FEDERAL COAL
EXPLORATION LICENSE APPLICATION
&
EXPLORATION PLAN FOR CONSTRUCTION OF
WATER MONITORING WELLS
COTTONWOOD CANYON AREA
EMERY COUNTY, UTAH

Re: Cottonwood Creek Drilling Plan for 1992, Holes CCCW1 through CCCW4, PacifiCorp, Deer Creek Mine, CEP/015/018-92B, Folder #2 and Exploration Folder, Emery County, Utah

RE: 1992 Cottonwood Creek Drilling Plan, holes CCCW1 - CCCW4;
Pacificorp Electric Operations, Deer Creek Mine, ACT/015/018, Emery
County, Utah

COTTONWOOD CANYON
WELL DESIGN - STARPOINT/BLACKHAWK CONTACT
FIGURE 3

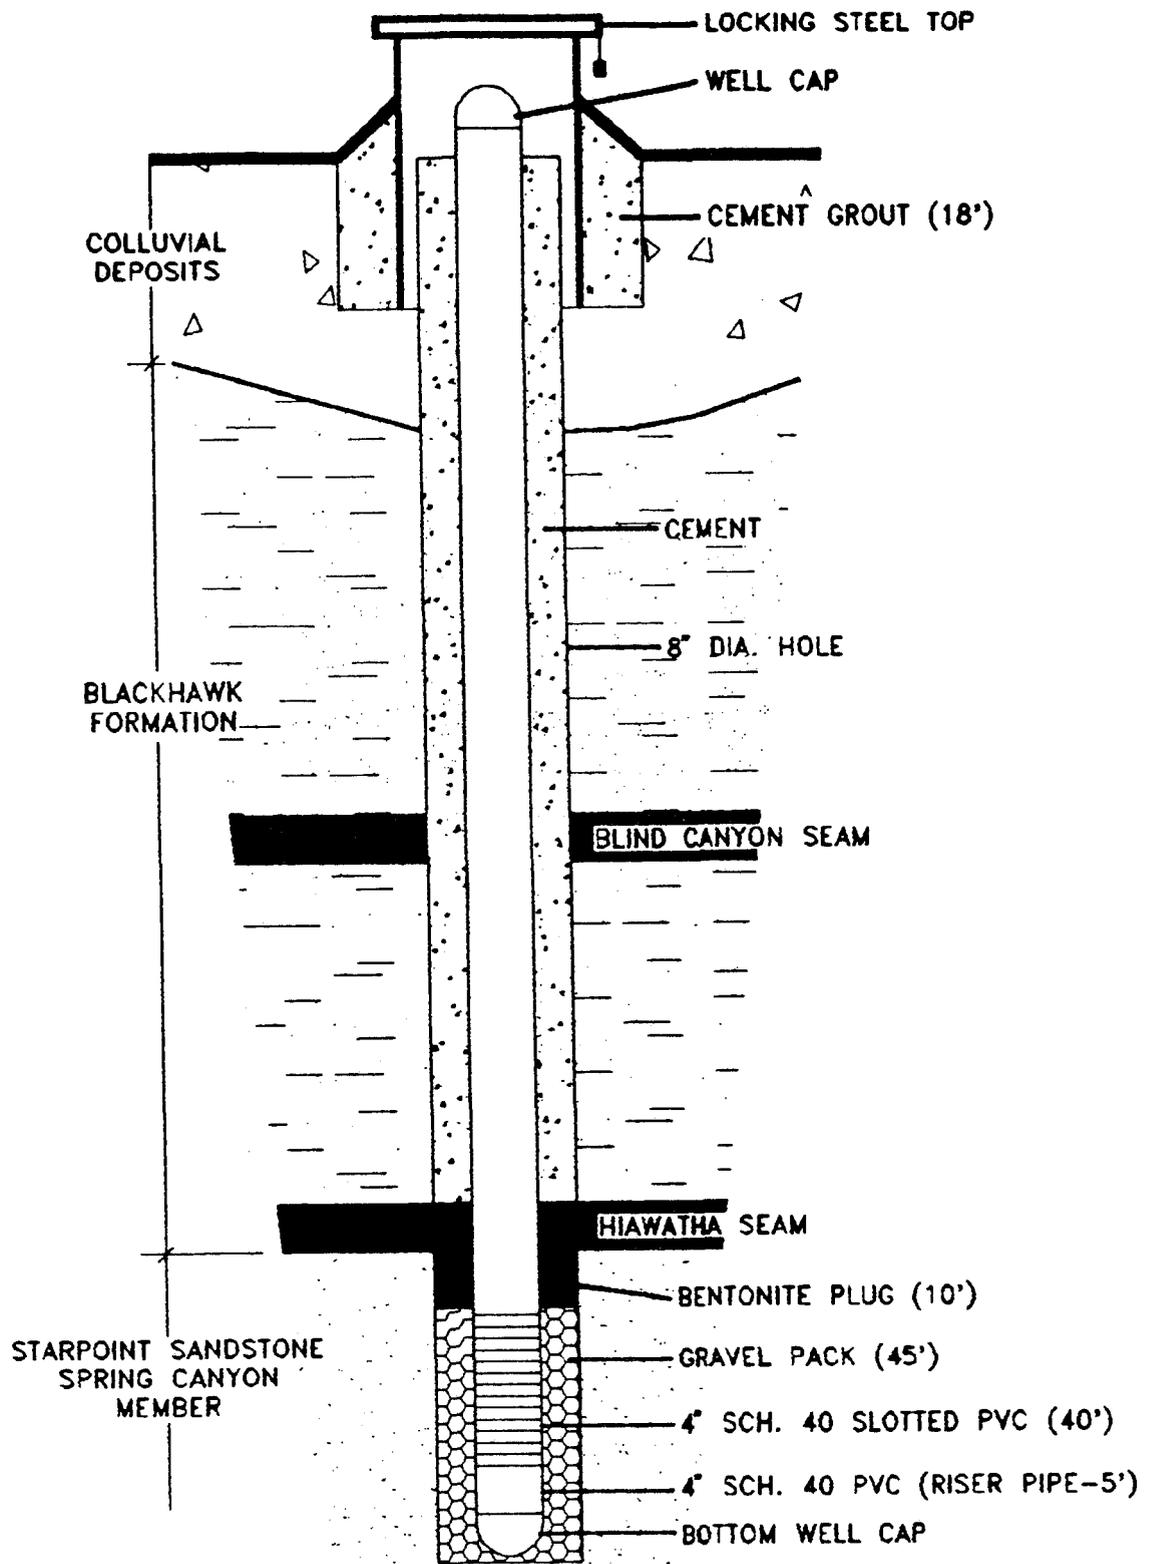
ground w cement
as shown on Fig 3.

what about
drilling with
S forms +
Pantler
S/A.
